Model: SR210 (Finisher for AD1) Date			: 30-Jun-97	No: 001	
Modified Article: Main Control Board			Prepared by: M.Horiike		
From: QAC 2nd Fiel	d Information Dept.				
Reason for	Parts catalog correction	☐ Vendor	cha	ange 🔲 To m	neet standards
Modification:	☐ To facilitate assembly	☐ To improve reliability ()			
	☐ Part standardization	Other

Model: SR210 Date			e: 15-Apr-98	No: 2	
Modified Article: Decal-Stapler			Prepared by: K.Ugaeri		
From: QAC Field Inf	ormation Dept.				
Reason for	□ Parts catalog correction	☐ Vend	lor ch	ange 🔲 To n	neet standards
Modification:	☐ To facilitate assembly ☐ To improve		nprov	e reliability ()
	☐ Part standardization	Othe	r

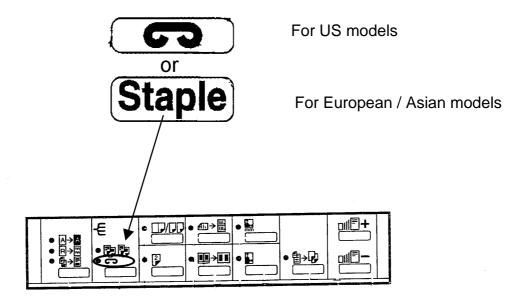
The following decal is missing. Please add this part to your part catalog.

After installing an SR210 on an AD1 or AD1E, this decal must be put on the operation panel as shown below.

Old part	New part	Description	Qty	Int	Page	Index
number	number					
	A6664940	Decal – Stapler	1

2. ENTRANCE SECTION (A666)

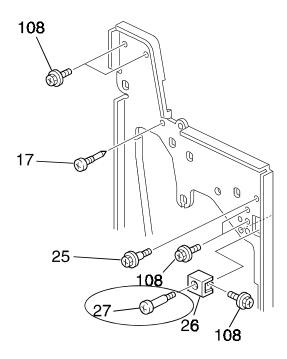
The index no. 27 on page 5 of the parts catalog is not mentioned. Please add the following part to your parts catalog.

Part		Index
No.	Description	No.
A6661419	Stepped Screw – M4 x 6	27
